Department of Energy  
Washington, D.C. 20545  
Docket No. 50-537  
HQ:S:82:098

INSTRUMENTATION (CHAPTER 7) WORKING MEETING, SEPTEMBER 21 and 22, 1982 -  
ADDITIONAL INFORMATION

Resolution of Items From the September 21 and 22, 1982 Instrumentation (Chapter 7) Working Meeting

Figure 7.2-2A. Typical Primary HTS Instrument Channel Logic Diagram  
HTS PUMP FREQUENCY

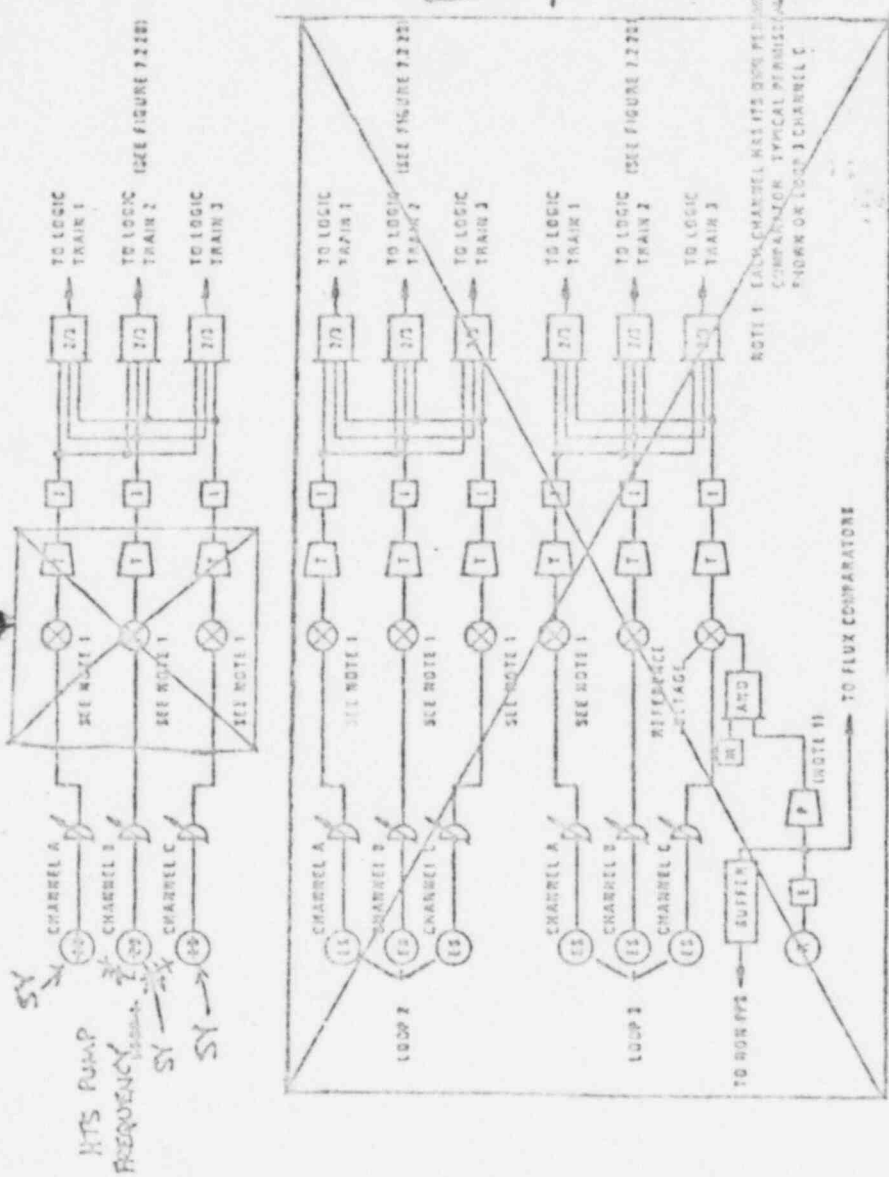
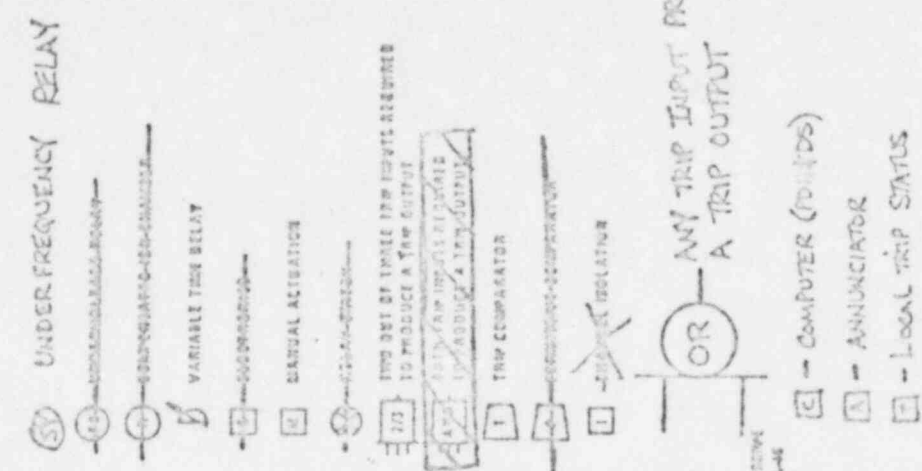
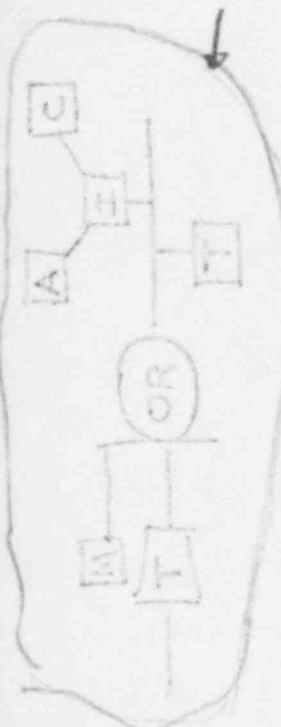
21. - RSS bypass capability	Delete existing two loop operation I&C. Correct PSAR.	PSAR corrected. See PSAR page 7.2-1a, attached.
22.	Provide revised Figure 7.2- 2A. Place in PSAR.	Revised Figure 7.2-2A attached.

Bypass features included within the Primary and Secondary RSS hardware for two loop operation will be deactivated during all three loop operating modes so that the three loop operating configuration can not be affected by these bypass features either by operator action or by two loop hardware failure.

} new material  
to be  
inserted

INSERT FOR EACH CHANNEL

ANY TRIP INPUT PRODUCES A TRIP OUTPUT
